Technical note

Project:	A428 Study - Phase 2	To:	Adrian Shepherd
Subject:	Analysis of Consultation Proposals	From:	Atkins
Date:	1 Feb 2016	cc:	Ashley Heller

The aim of this technical note is to provide an initial analysis of the alternative proposals received as part of the public consultation on the A428 Cambourne to Cambridge Better Bus Journeys scheme. This technical note is a supporting document as part of the report to the City Deal Partnership on the outcome of the public consultation undertaken in the autumn of 2015. The written representations considered within this technical note will, as required be assessed as part of the appraisal of options and feasibility for the scheme

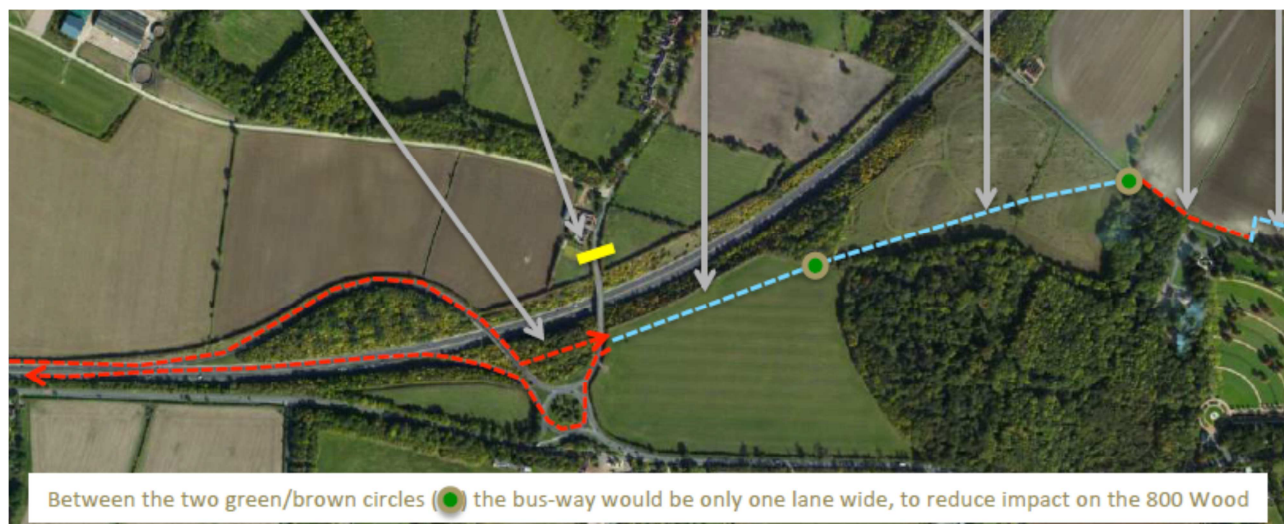
- the area is very sensitive, being at the top of Madingley Hill, with its important views and location
- we worry about the effect of car emissions, as they enter/exit a Park & Ride and park their cars, on the ecology of Madingley Old Wood, a Site of Special Scientific Interest (SSSI)
- there would be too much harmful impact on the nearby villages of Madingley and Coton

The landscape character of the area will be considered when assessing the potential locations of a Park and Ride at Madingley Mulch roundabout. Should visual character be affected, mitigation measures such as screening will be considered.

The effect of vehicle emissions on the Madingley Wood SSSI will be included as part of the air quality assessment of the P&R, if the SSSI is within 200 m of the P&R itself or the access roads (hence this is likely to be a consideration for the NE and SE sites). The assessment would consist of calculating annual average NO_x concentrations in the SSSI both with and without the P&R. The NO_x concentrations would be compared with the criterion for vegetation and ecosystems to see if it is being exceeded, and to determine the change in NO_x concentrations in the SSSI. In addition, nitrogen deposition would be calculated within the SSSI and compared with the relevant critical load. The results would be evaluated and consideration

given to potential impact on the SSSI. If there was a significant risk of an adverse effect, then mitigation measures should be undertaken to minimise the impact.

4.6. Option 1 Central /1 North with a route through West Cambridge

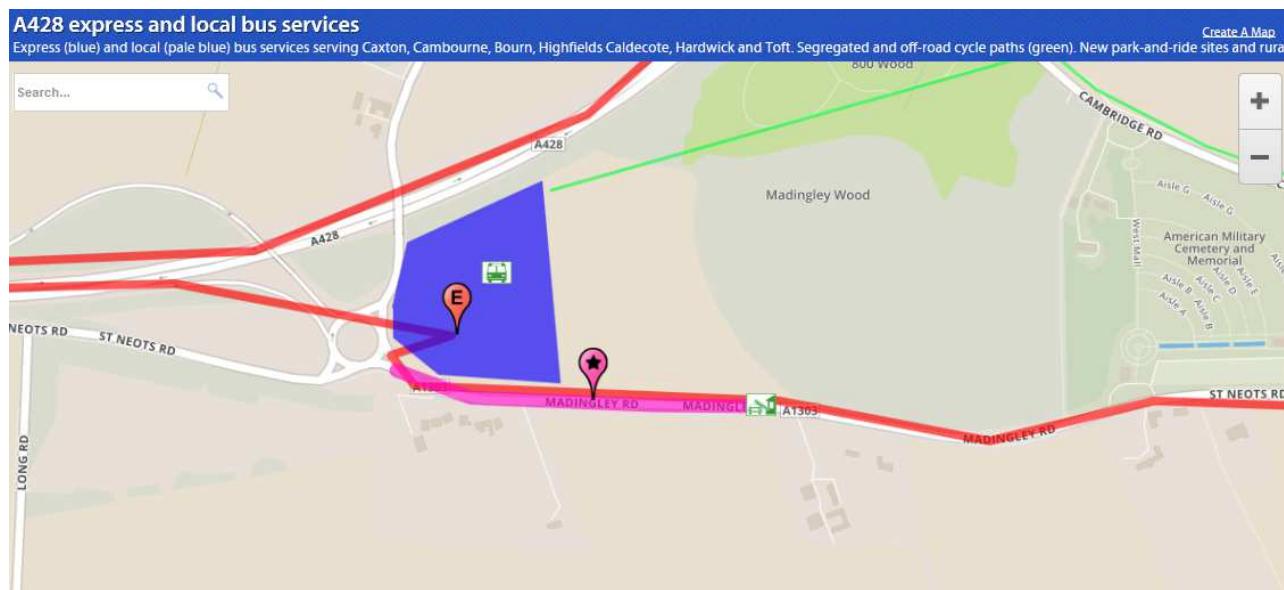
These proposals involve using similar infrastructure to that proposed for Options 1 Central and 1 North for the Madingley Hill section of the route. Once buses have crossed the M11 using the existing route, they would enter the West Cambridge site and continue towards Grange Road by means of a possible combination of a segregated route and roadway.

The main benefit listed by promoters of this proposal is the use of the existing M11 bridge, thereby eliminating the need for a new structure, while still retaining some of the benefits of offline segregation of Option 1 South. Limiting the impact to Coton is also listed as an advantage.

As proponents described, this route albeit a compromise of two options may potentially realise some of the benefits of off-line alignment while limiting the overall scheme cost, as a new bridge over the M11 would not be required.

The route through West Cambridge also has the potential for increased patronage should development at this location continue. A bus stop might be located towards the centre of the site and may therefore attract more users than that on Madingley Road.

Adams Road and Herschel Road are perhaps two of a number of potential locations where this route's exit onto Grange Road could be achieved. Initial assessment indicates the need for complementary on street measures.

4.7. Smart Traffic Management

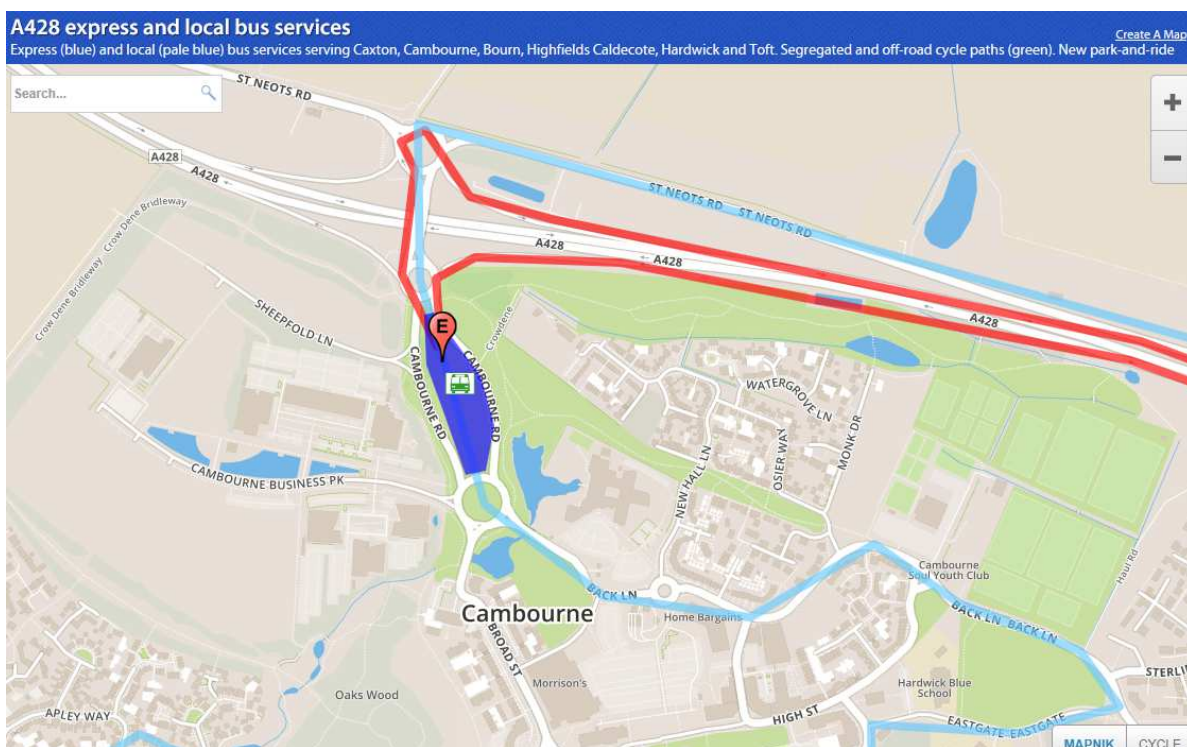
This proposal as understood involves using signals to regulate traffic flow into the City. Construction of a 500m queuing lane on Madingley Hill and a similar one on the M11 slip road are proposed for traffic to wait until access is provided. A bypass lane for the bus would be introduced at this location.

The map below shows the proposed bus route (in red) and the location where road widening would be required to accommodate the queuing lane (in pink).

As proponents described, this arrangement can help regulate flow. However, the proposed measures do not reduce congestion but instead relocate it. As a result, the proposal is unlikely to support growth, one of the City Deal objectives.

Widening the existing road to provide queuing space is not an effective use of the highway, which instead could be widened to provide a bus lane. If buses share road space with other traffic once past the queuing locations, mode switch will not be encouraged to the same extent as in the original proposals.

For the bypass lane to be as effective as a bus lane, regular traffic would need to be held back until the entire length of the queue clears (usually from the M11 to Madingley Hill), otherwise buses would travel past the signals and immediately encounter the back of the following queue. Holding back traffic to this extent would lead to very high queuing times and queue lengths, and it is likely that traffic would relocate to other radial routes. Long queue lengths may also tail back to the M11 or A428, where they may pose a safety risks for both drivers in the queue and other road users.

The assessment of queue space required included in the proposal assumes that queuing space should be proportionate to the length of the congested route. This assessment assumes traffic is completely stationary, which is not correct. Since traffic is flowing (albeit slowly) the assessment should be based on flow, not route length.

For example, if the flow on Milton Road is 1000 vehicles/hour, 20% of that is 200 vehicles which each need 6m to stack giving 1.2km of new carriageway to provide. This is four times the length identified in the example worked through by the proposer.

4.8. Additional P&R north of Cambourne

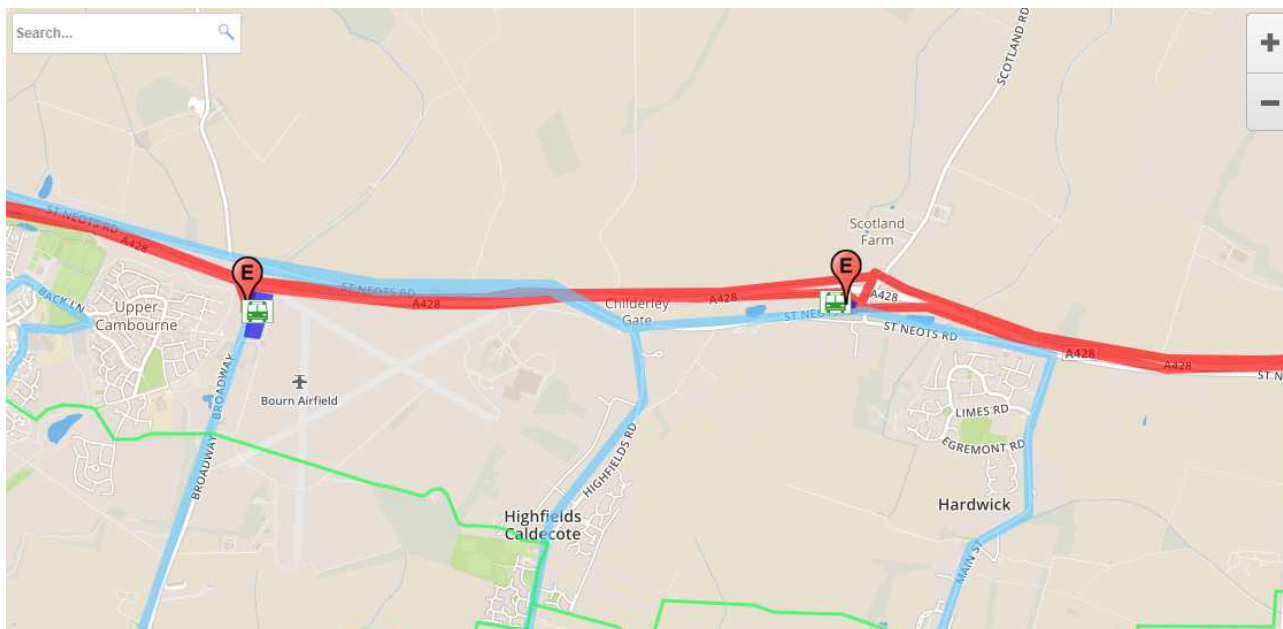
This proposal involves the creation of a new Park and Ride in the vicinity of Cambourne. Two potential locations have been suggested: between the two roundabouts south of the A428 access, and north of the junction with the A428.

Note the area in the second image has been shaded based on Atkins interpretation of the description in the alternative proposal.

With regards to interception, considerations are similar to those listed in section 4.1.2 above, which states driver behaviour will likely limit mode switch for P&Rs located at points where congestion is not visible.

Walk-and-ride patronage from Cambourne will be present, but this could also be achieved by providing bus stops in Cambourne. Interception of vehicles further east than Cambourne will only be possible at the Madingley Road P&R, and congestion on Madingley Hill is likely to persist as a result.

Operation costs are also likely to be higher for Park and Rides further from the end of the bus route, as more buses will be required to operate the same route, and result in economic dis-benefits when compared to a closer location. The magnitude of this effect cannot be quantitatively assessed without further analysis.

These three considerations indicate that locating a Park and Ride at Cambourne will be less beneficial than locating it further east (e.g. at Madingley Mulch and Scotland Farm), where the congestion starts, patronage will likely be higher and operating costs are lower.
